PROPOSED DRAWING CORRECTIONS
OR APPROVAL BY EXAMINER

S.N. 09/954,821
Examiner C. Tyler
Art Unit 3746

FIG. 2

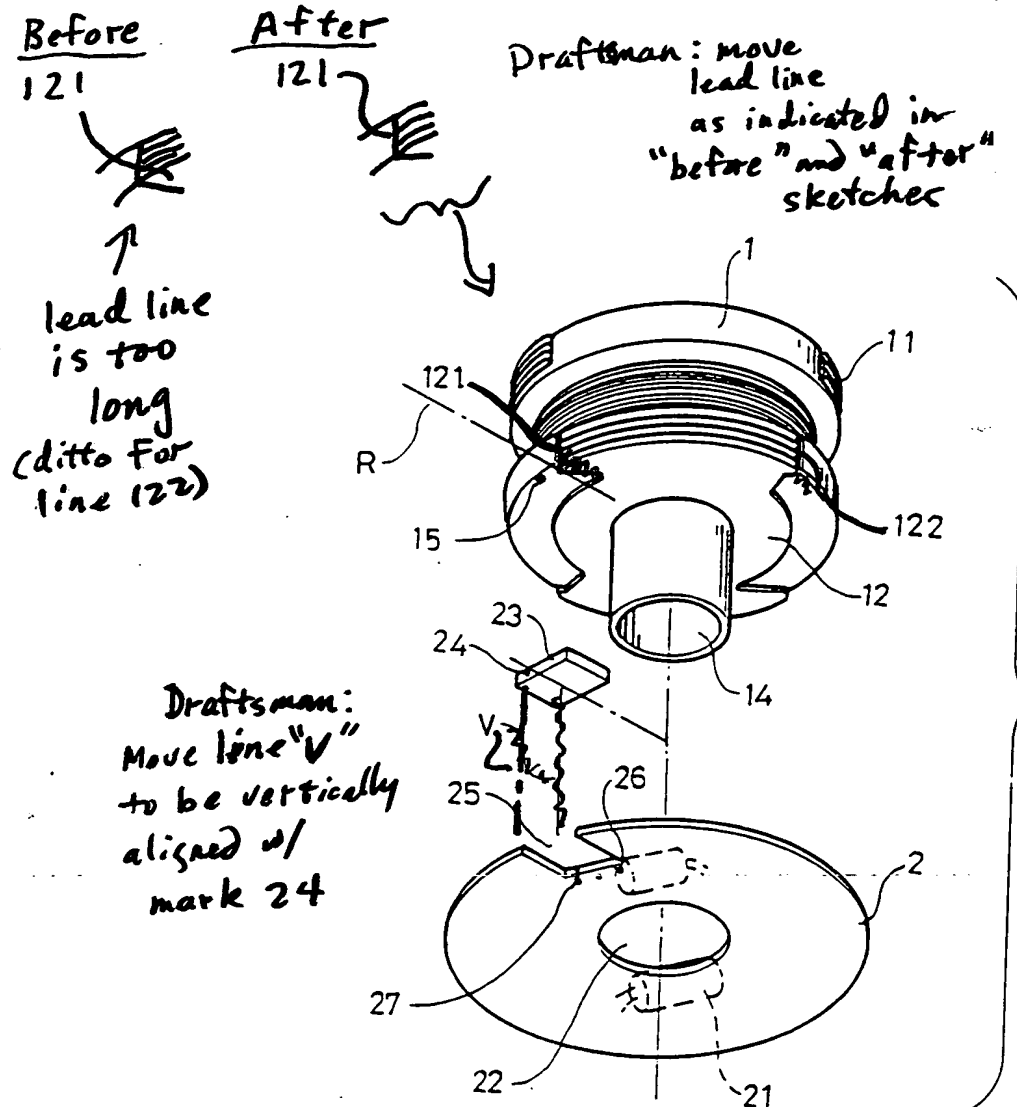
Note to
Draftsman:
See Fig. 3
for details
on where to
move lead line
121 & line "V"
